Ordinary Council Meeting

Monday, 16 December 2019

SY180-12/19	Development Application: Supermarket (Shop), Shops, Medical Centre and Community Purpose Development: Lots 3 (88) and 820 (94) Avon Terrace and Lot 25 (19) Monger Street, York	
Appendix 1	Site Plan.....	4
Appendix 2	Advertised Development Application	5
Appendix 3	Amended Development Plans	12
Appendix 4	Transport Impact Statement	18
Appendix 5	Flood Risk Mitigation Plan	51
Appendix 6	Officer Assessment: Local Planning Policy Heritage Conservation and Development.....	58
Appendix 7	Heritage Advisor Comments.....	66
Appendix 8	Schedule of Submissions	72
Appendix 9	Copy of Submissions Recieved	75

Figure 11. Sightline assessment of the development Avon Terrace crossover

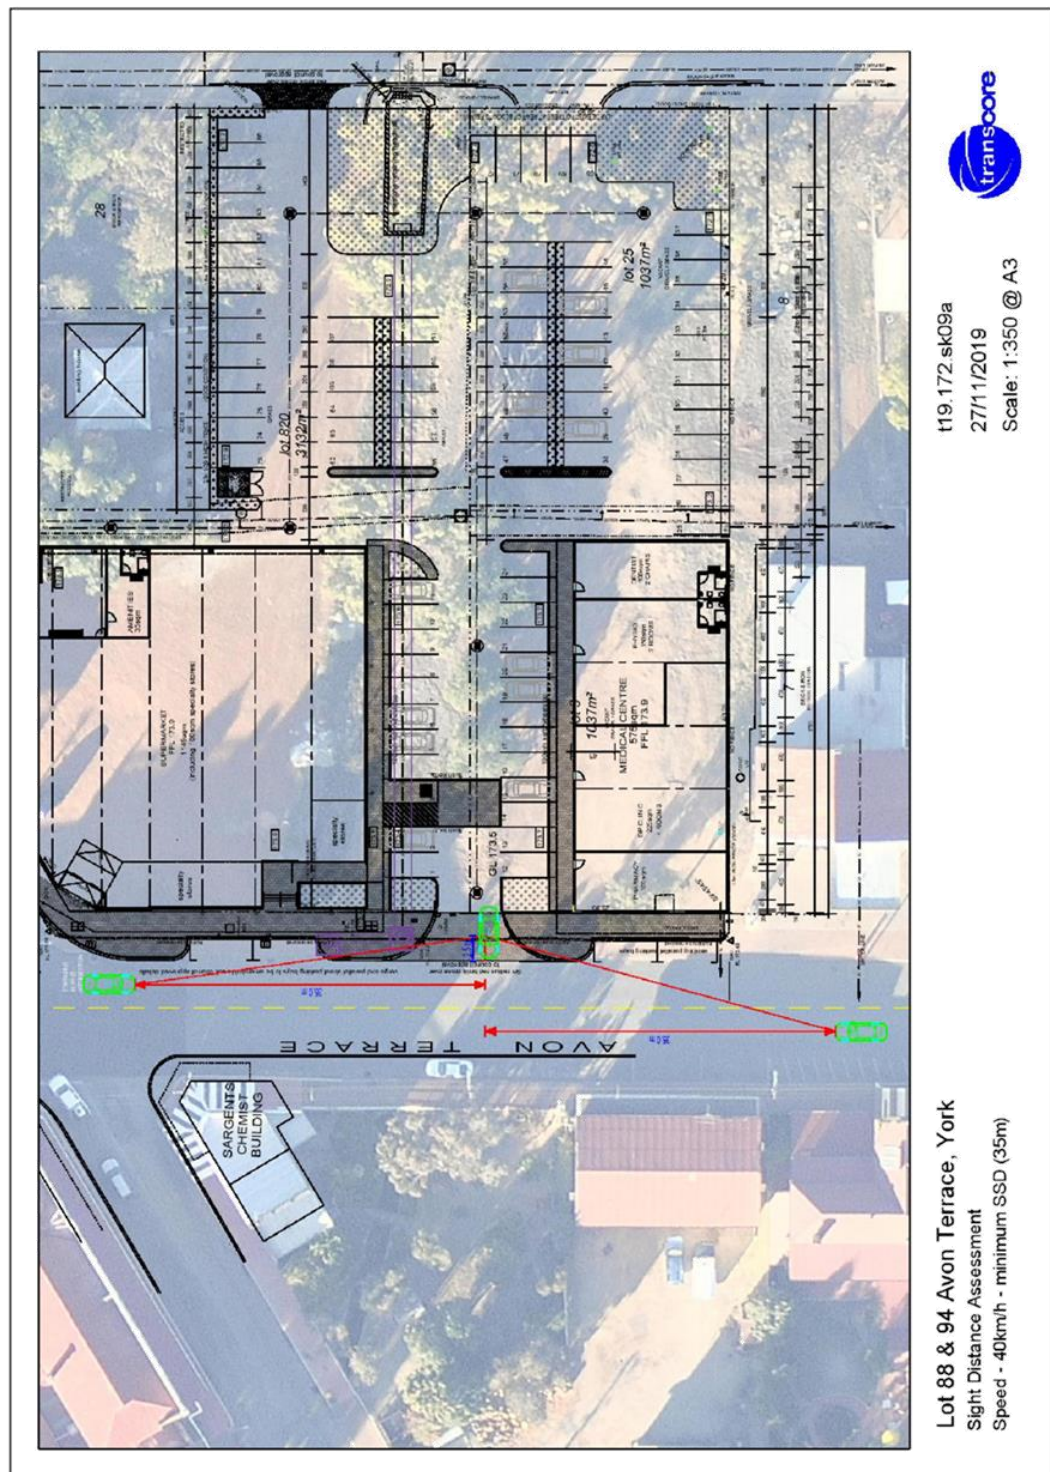
In order to ensure the safe operations of the Avon Terrace development crossover a sight line assessment for the proposed crossover was undertaken. In accordance with Figure 3.2 of the *Australian Standards AS/NZS 2890.1: 2004 – Parking Facilities Part 1: Off-street car parking*.

As shown in **Figure 10**, the speed limit for Avon Terrace in the vicinity of the subject site is sign-posted as 40km/h. In order to achieve the sight distance as specified in Australian Standards, the original development site plan was amended by removing two on-street parallel parking bays adjacent to the proposed Avon Terrace crossover. The original site plan is included in **Appendix B**.

As evident from **Figure 11**, the proposed four on-street parallel parking bays in the revised site plan in **Appendix A** do not impact on the sight line for vehicles exiting the development Avon Terrace crossover.

TURN PATH ASSESSMENTS

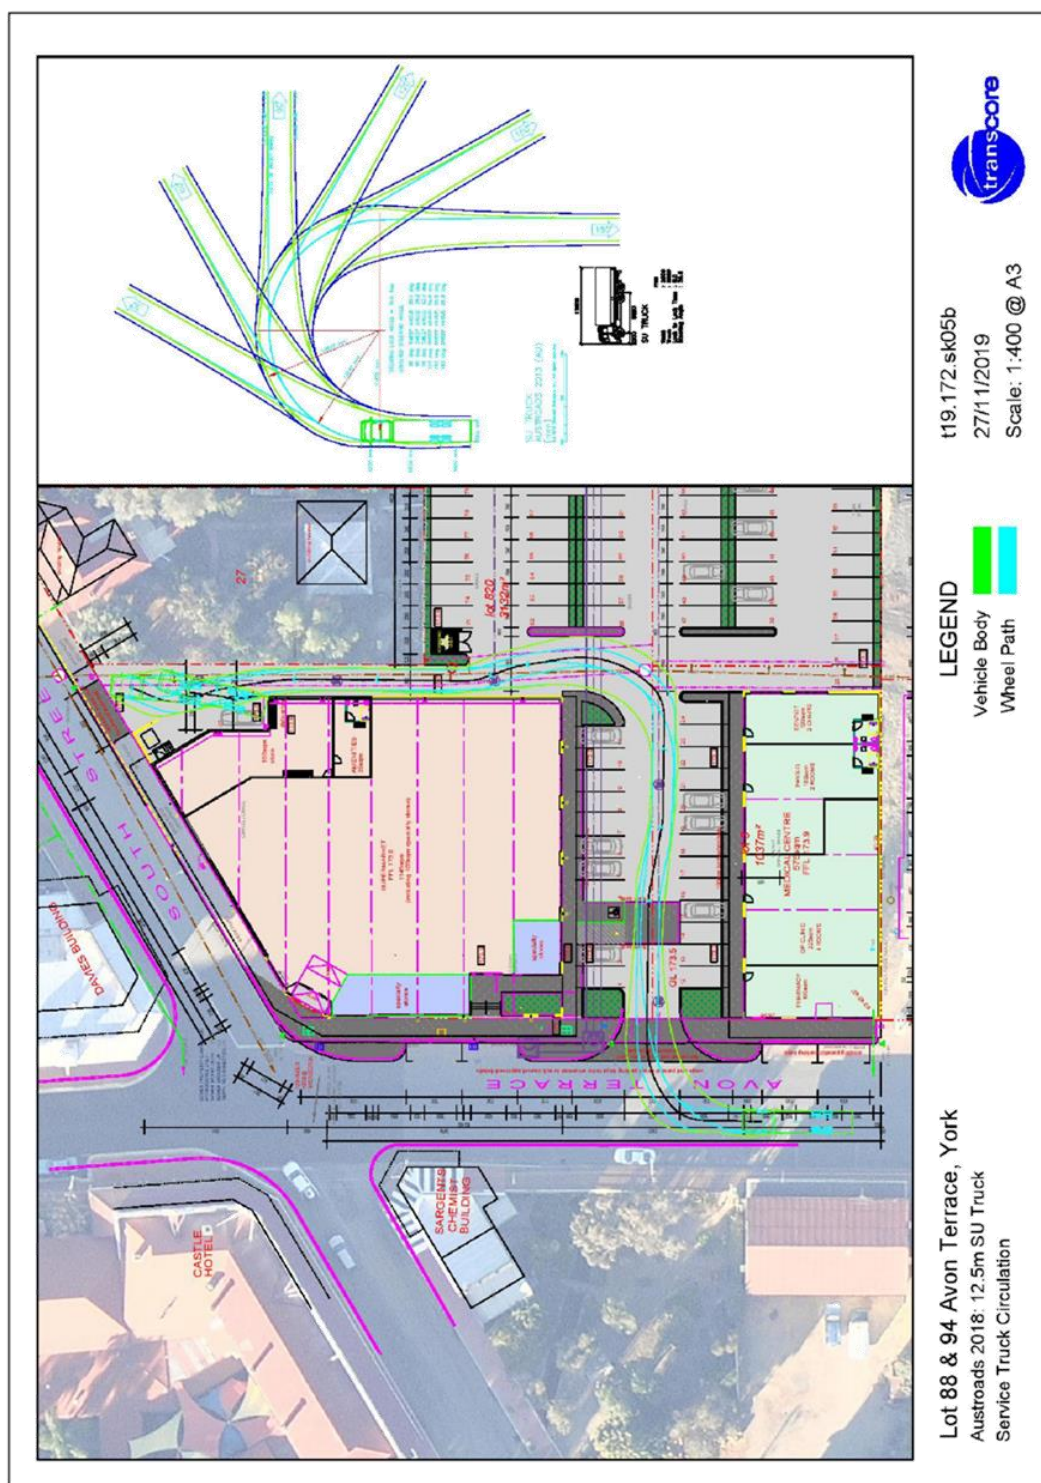
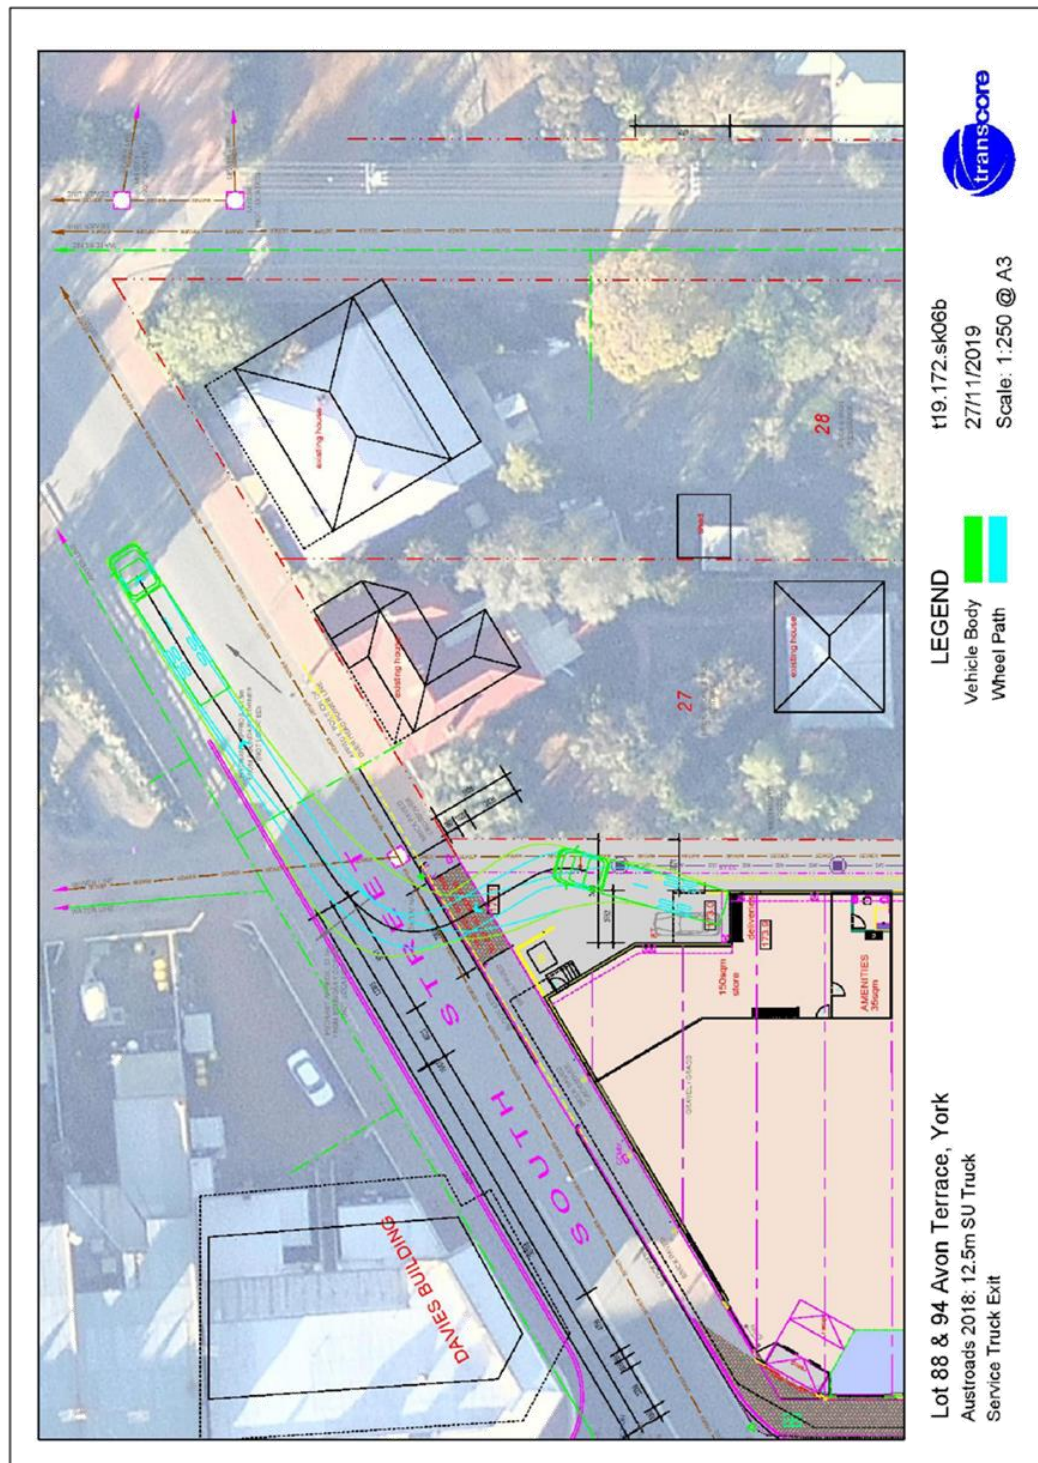
Based on the information provided to Transcore, it is anticipated that 12.5m single unit service trucks will be used for deliveries and waste collection. Swept path analysis undertaken confirms the satisfactory entry, egress and circulations of 12.5m service trucks. Swept path plans are included in **Appendix C**.
